REPORT TO THE BELOIT LANDMARKS COMMISSION

Meeting Date: July 15, 2008

File Number: COA-2008-21

Location: 617 Harrison Avenue

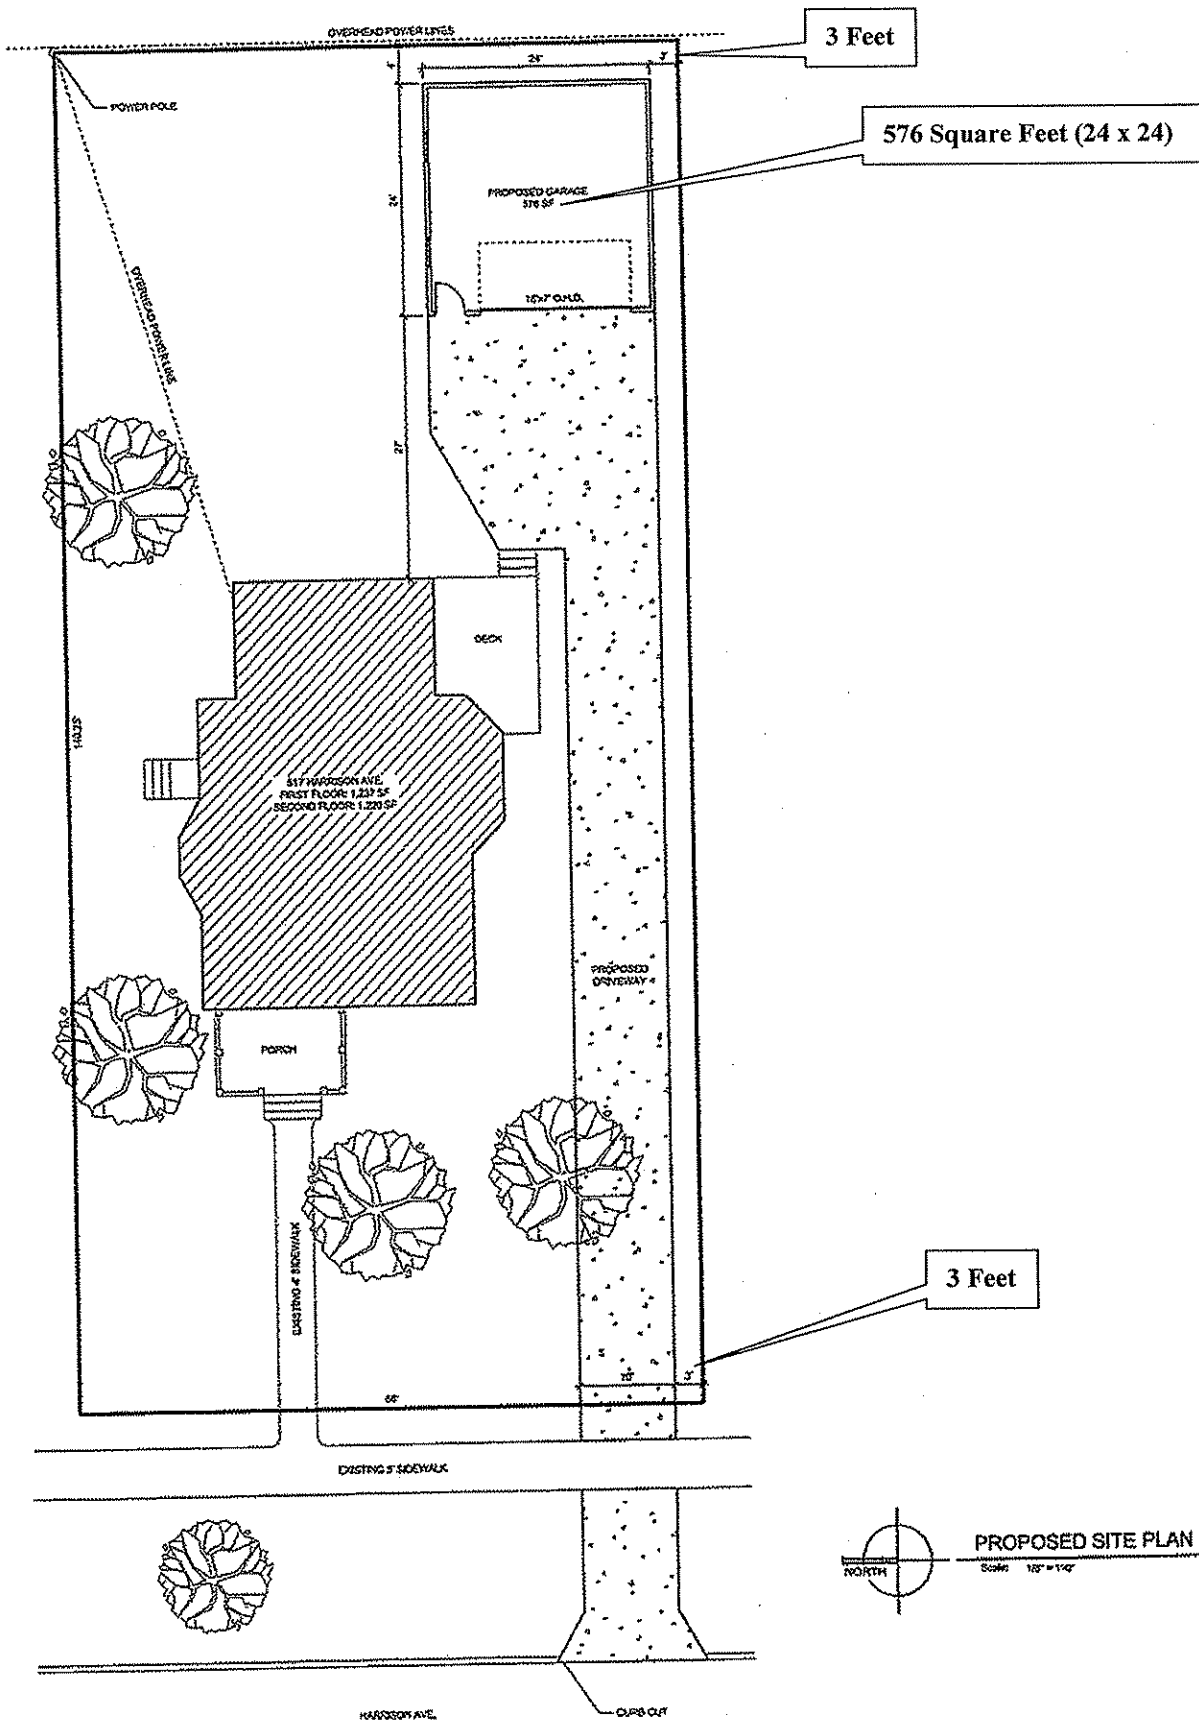
- Planning and Engineering staff have surveyed the subject property and have several observations regarding the proposed site plan. The site plan does not show a large tree along the southern property line (near the street). The driveway cannot be constructed exactly as shown on the site plan, as the tree is in the path of the driveway. The proposed driveway, if approved, will need to be set back approximately five feet from the southern property line. This setback will allow the driveway to fit in between the two mature trees in this area that are approximately eleven feet apart. Planning staff feels strongly that all of the mature trees on this property must be protected and retained before, during, and after this project.

5. The new driveway shall be set back at least four feet, ten inches (4' 10") from the southern property line and shall extend in between the mature trees on the subject property. The trees on the subject property shall be protected before, during, and after completion of this project.

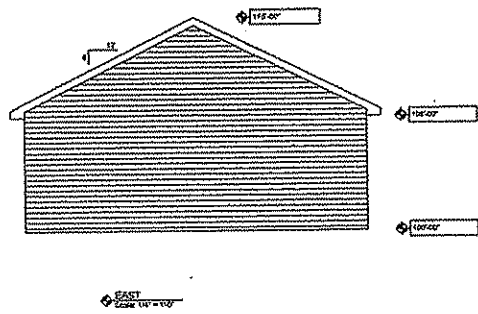
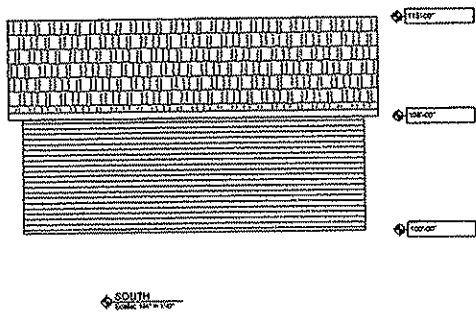
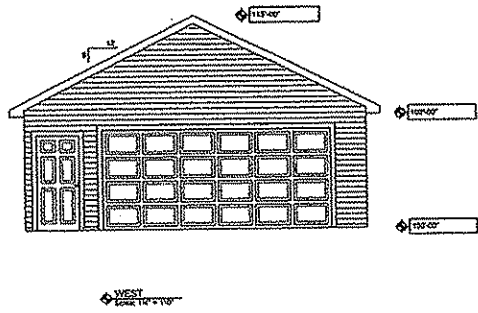
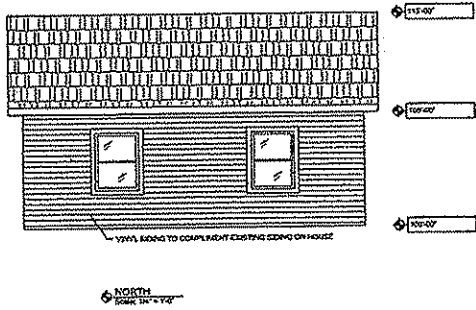
- The proposed garage will have vinyl siding and a gable roof. Black and white exterior elevations are attached to this report and a manufacturer's pamphlet detailing vinyl siding options is on file in the Neighborhood Planning Division.

The proposed garage includes one overhead door, one access door, and two windows on the northern façade. Staff feels that the relationship between the proposed garage's doors and windows is compatible with the historic house and with the surrounding structures in the historic district.

The proposed gable roof is compatible with the architectural style of the historic house.

1. All work must be completed by December 31, 2008.
2. The vinyl siding to be installed on the detached garage shall closely match the house siding in color and width. The shingles to be installed on the detached garage shall closely match the house shingles in color and texture.
